**TOWN OF ADDISON  
BUILDING REPORT**

**Facility Information:** **Facility Name:** Athletic Club  
**Facility Contact:** Lisa Pyles **Contact Phone:** 972-450-2878

**Accessology Inspector Information:**  
**Inspector:** Karen Jackson **Date:** April 25, 2017  
**Email:** Kjackson@accessology.com

**Latitude:** 32.950273 **Longitude:** -96.848428  
**Address:** 3900 Beltway Drive **City:** Addison **County:** Dallas

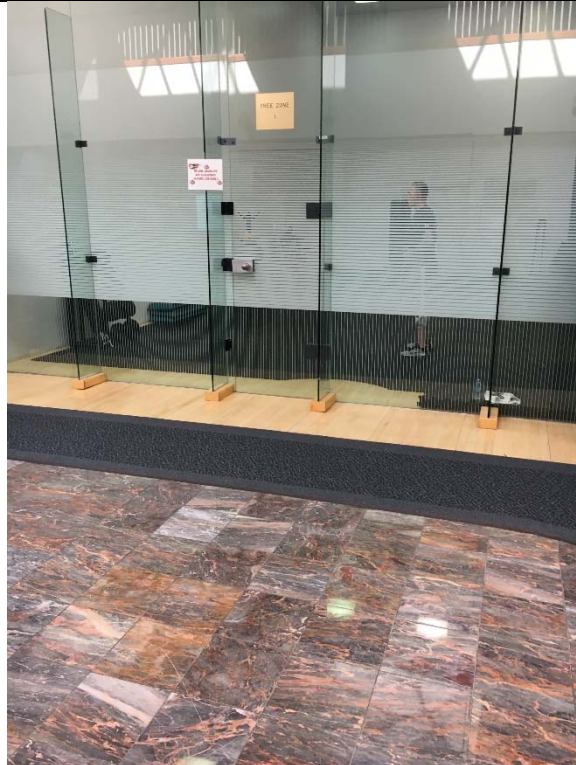
**Violation 46** - The 2nd floor breakroom door only has a 29" opening where a minimum of 32" is required.

**Violation 47** - The sink in the 2nd floor break room is at 36 1/4" with no knee clearance provided.

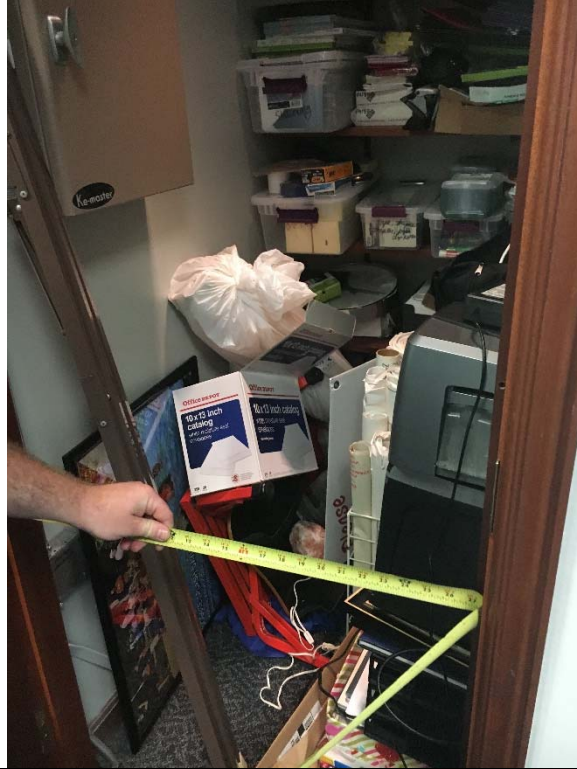
**Violation 48** - The microwave in the 2nd floor break room is mounted over the stove and out of the required reach range.

**Violation 49** - The doors leading into the racket ball/individual exercise rooms only have a 29" opening with door hardware requiring grasping and twisting to operate.

**Violation 50** - There is an 11/16" change in level to enter the gymnasium.

Modify entrance into the gymnasium to achieve a change in level no greater than 1/2".

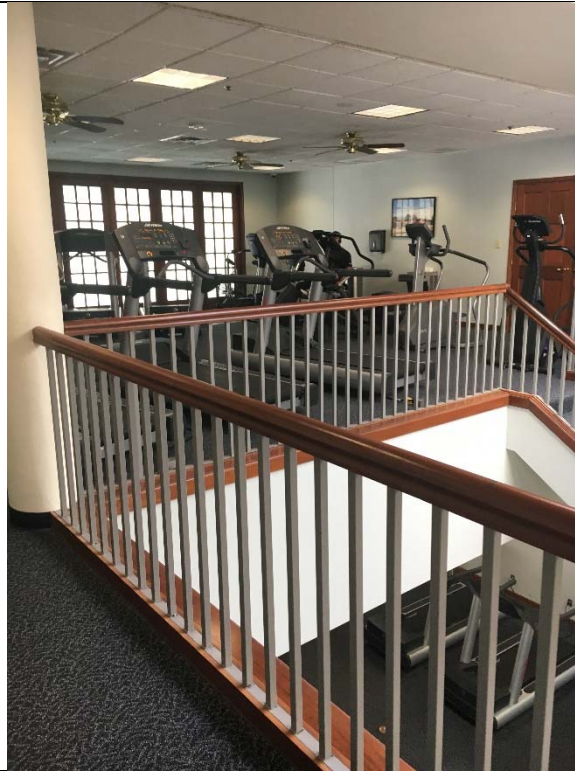
**Violation 51** - The counter in the conference room is at 39-3/4", where a maximum of 36" is required.

**Violation 52** - The storage closet door on the 2nd floor only has a 28" wide opening.

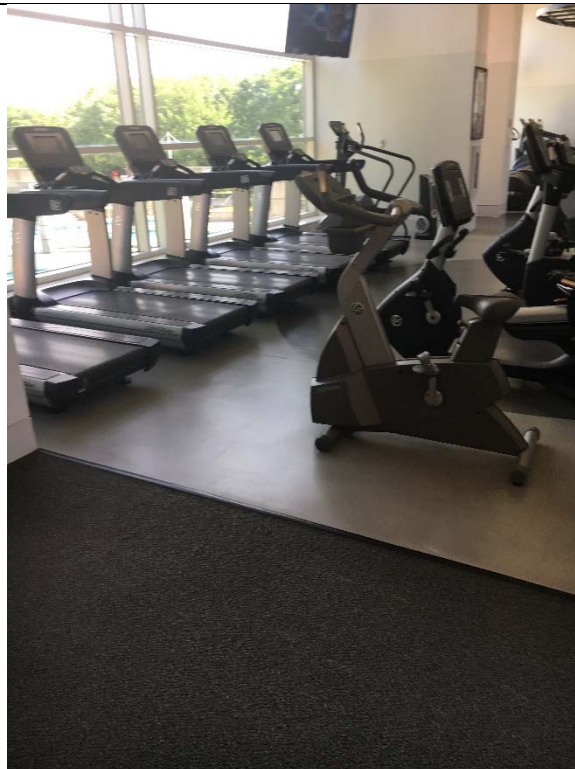
**Violation 53** - The exercise areas in the mezzanine area on the 2nd floor only have one drinking fountain on each end, both of which are at accessible height.

Add a drinking fountain for standing persons.

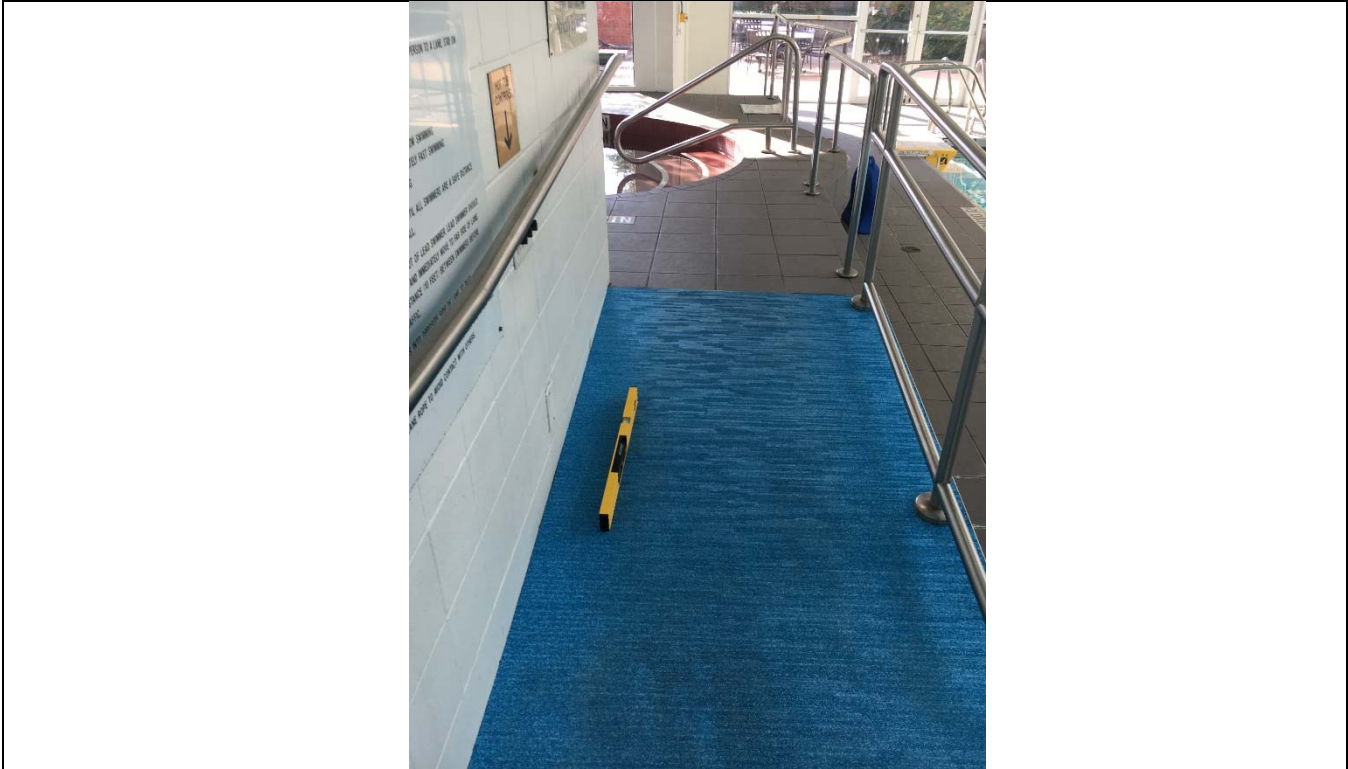
**Violation 54** - The drinking fountains outside the restrooms by the track on the 2nd floor block the maneuvering depth clearance required on the pull side of the Men's room door. Additionally, the high fountain is a protruding object.

**Violation 55** - Not all of the exercise equipment has the required clear floor space provided next to it.

**Violation 56** - The exterior drinking fountains do not have a compliant clear floor space provided. The paving is too narrow and drops down into the dirt and grass area. There is also a utility cover in front of the drinking fountains causing an uneven surface.

**Violation 57** - There is no accessible means of entry into the exterior pool.

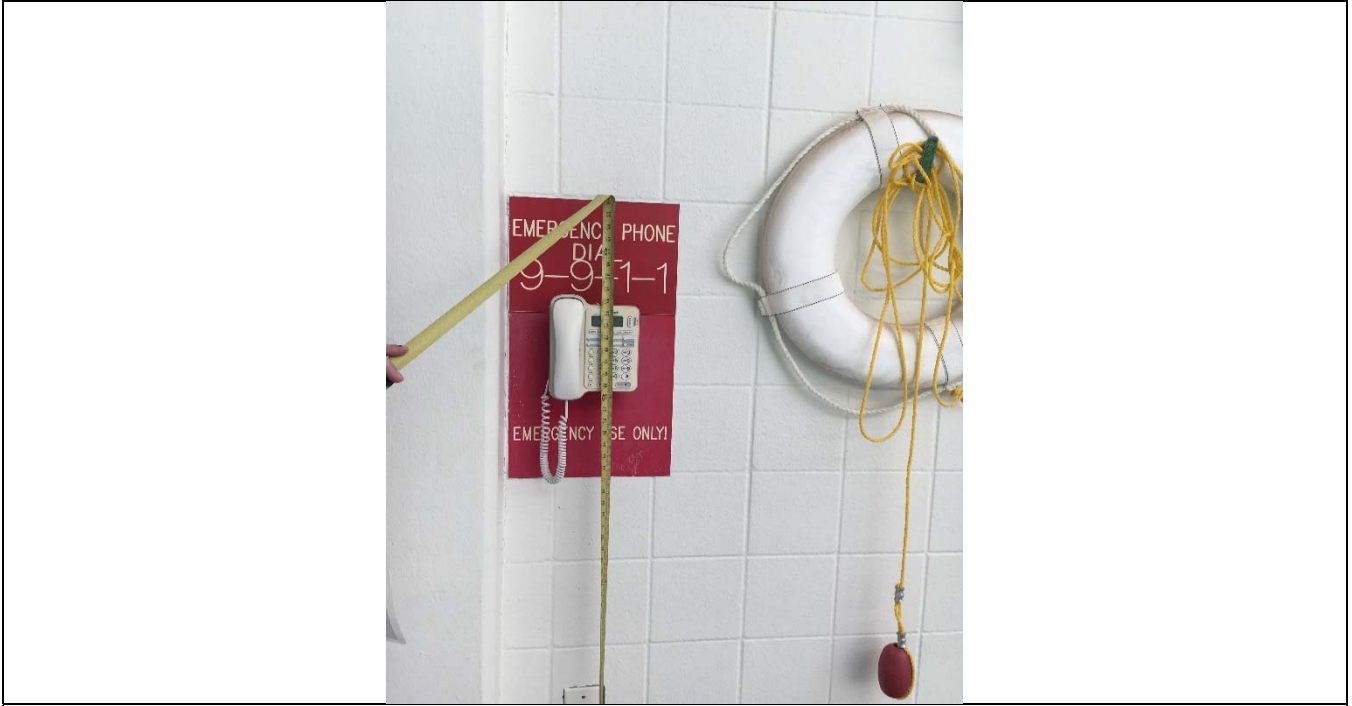
**Violation 58** - Coat hooks provided at the indoor pool area are at 61" where a maximum of 48" is required.

**Violation 59** - The lower portion of the ramp in the pool area has a running slope of 8.6%.

**Violation 60** - The controls for the hot tub located at the indoor pool area are located on the ramp and not served by a level clear floor space.

**Violation 61** - The emergency shut off bottom at the indoor pool is mounted at 50", where a maximum of 48" is required.
